13553  
28 January 2015

**18-22 OCEAN STREET NORTH AND 30 WELLINGTON STREET, BONDI  
PANEL REFERENCE 2014SYE115**

**Figure 1 – Extent of the 6m blast zone if the substation is located adjacent to Building A**

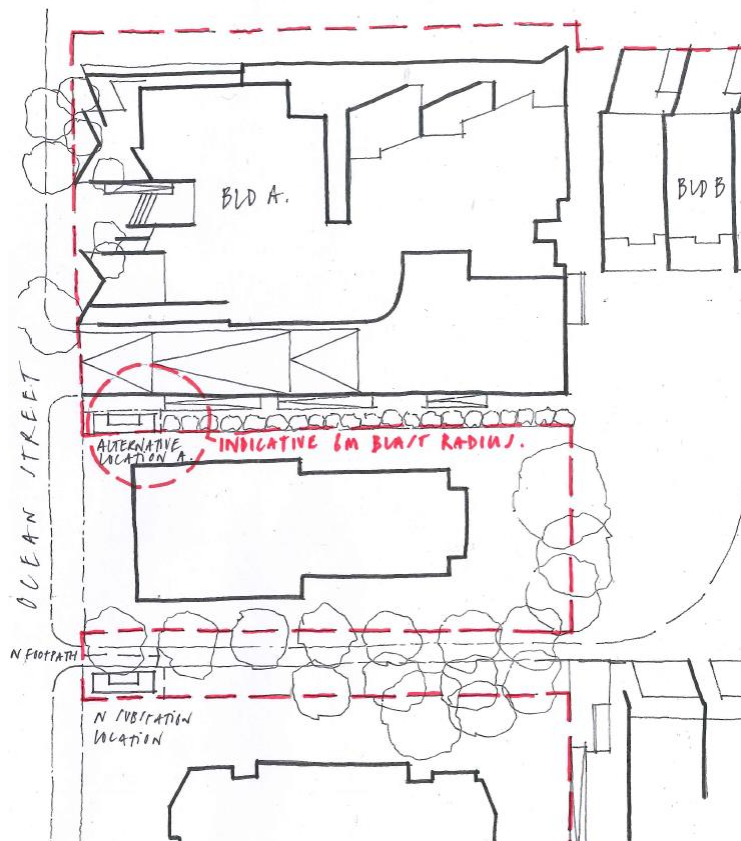
- Mirvac were advised during due diligence that the substation was required to be located behind the property boundary on ground that is within a few hundred millimetres of the level of the existing road. There are only two locations on the site that meet this requirement, being the proposed location on Ocean Street North and the southern boundary of the site on Wellington Street. The southern boundary location has been discounted as it would require extensive trenching which would interfere with the Structural Root Zone of the heritage listed Norfolk Island Pine.

- The proposed location provides unobstructed level access for installation and ongoing maintenance in accordance with Ausgrid Network Standards.
- Options to incorporate the substation into the building were also discounted due to the adverse impact it would have on the design and architecture of the buildings as a result of Ausgrid's access requirements and the need to provide adequate blast proofing. Relocating the substation to the walkway alongside Building A was considered, however for safety reasons, the substation and any building openings to habitable space are required to be separated by more than 6m, which is not achievable in this location due to the proximity of the neighbouring property. The sketch at **Figure 1** indicates the 6m blast radius and the impact it would have on the neighbouring building. In addition, the opportunities to provide landscaping to screen the substation are more limited adjacent to the driveway entry. An example of the type of poor design outcome that would result from locating the substation adjacent to Building A is provided in **Figure 2**.

- Ausgrid's Contestability Manager has confirmed that the kiosk substation can be screened by hedges, shrubs, climbing plants and / or fences up to 2 metres tall to reduce the visual impact on the streetscape and through-site link, provided gates are supplied to provide adequate access. IGS has had a preliminary discussion with Aspect Studios and believe that an appropriate solution can be reached. An image indicating the type of screening that can be achieved has been prepared by Aspect Studios, and is provided at **Figure 3**.
